Subject: Technical Letter Report with Open
Items for the South Texas Project FSAR Section
2.4.6 Tsunami

**Technical Letter Report
to the U.S. Nuclear Regulatory Commission
JCN Q-4151, Task Order No. 2**

**Technical Evaluation Report with Open Items for the
South Texas Project FSAR Section 2.4.6 Tsunami**

By Eric L. Geist (USGS, Menlo Park), Patrick J. Lynett (Texas A&M University), David C. Twichell (USGS, Woods Hole), Uri S. ten Brink (USGS, Woods Hole), Bruce Jaffe (USGS, Santa Cruz), and Jason Chaytor (USGS, Woods Hole)

Figure 2.4S.6.4.1-2: Synthetic tsunami time series for the applicant's PNG source scenario at the location indicated in Figure 2.4S.6.4.1-1 ("Buoy Record") from applicant's RAI response (their Figure 18).

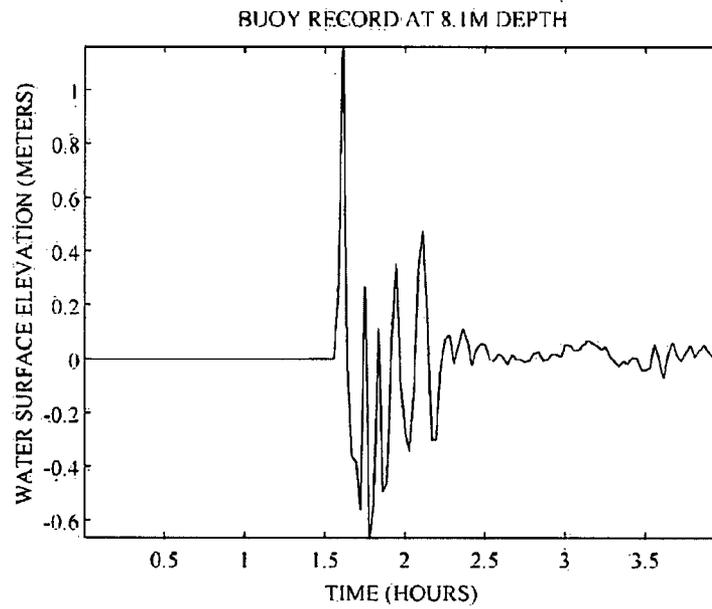
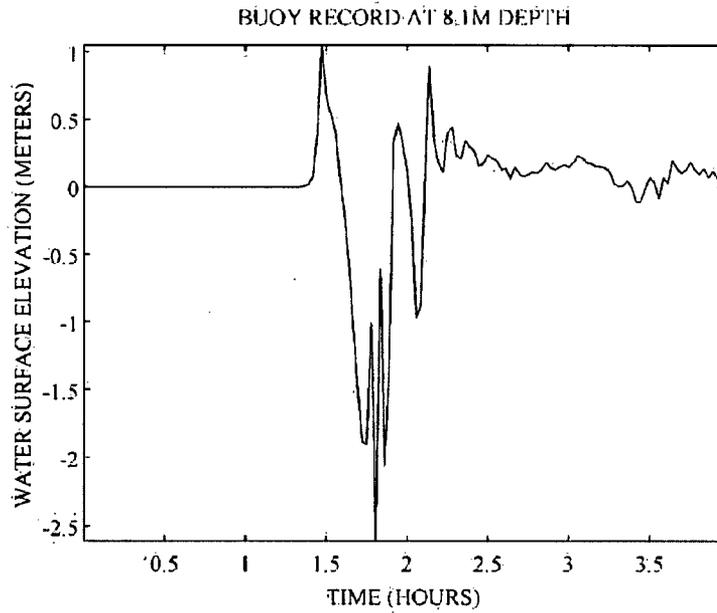
As is evident by comparing Figure 2.4S.6.4.1-2 and Figure 2.4S.6.4.1-3 with Figure 2.4S.6.4.1-4, there is approximately an order of magnitude difference in the maximum wave amplitudes between the applicant's and the staff's estimates (1+ meters versus 10+ meters). It is unlikely that this difference can solely be ascribed to differences owing to the station location and energy dissipation during propagation across the continental shelf. As indicated in Figure 2.4S.6.4.5-8 (1HD propagation) and Figure 2.4S.6.4.5-12 (2HD propagation) there is at most a three-fold reduction in amplitude during cross-shelf propagation, still suggesting a significant difference in the results using the applicant's methodology and our confirmatory analysis. The difference is likely caused by (1) a difference in source parameters; (2) the applicant using a center-of-mass generation model as opposed to our hot-start conditions using a cross-sectional profile of landslide motion and (3) lower bottom friction values used in our confirmatory analysis. For all of these differences, it is likely that the approach used in our confirmatory analysis is more conservative than the applicant's. Tsunami amplitudes decrease greatly during overland flow toward the plant as described in Section 2.4S.6.4.5, using conservative values of bottom friction onshore.

Figure 2.4S6.4.2-2: Excavation photo from applicant's RAI response (their Figure 23).

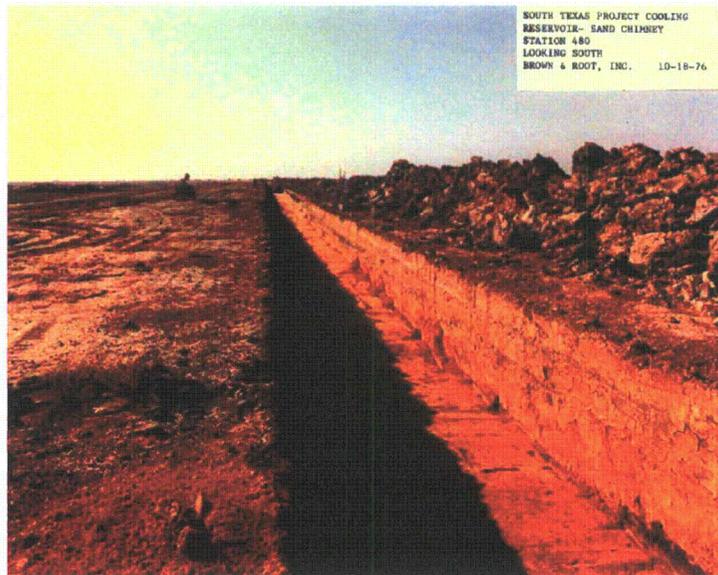
The applicant did not address possible evidence for paleotsunami deposits in the FSAR. In response the RAI 2.4S.6.1-1, the applicant provides three photos of the subsurface geology during excavation of Units 1 and 2. Two of the photos were taken a distance such that the stratigraphy is not discernable. The photo shown in Figure 2.4S6.4.2-2 (applicant's Figure 23 of the RAI response) indicates layers of different sediment: sand, silt and clay (according to the caption of the applicant's RAI response, Figure 23). The applicant indicates that the presence of sand is consistent with deposits emplaced in a "low-energy overbank floodplain adjacent to a meandering and avulsion-based deltaic river system" (pg. 23 of the response). Without additional details of these layers according to the specific sedimentological criteria for identifying tsunami deposits, the

applicant's statement that no evidence of tsunami deposits in these excavations cannot be independently confirmed.
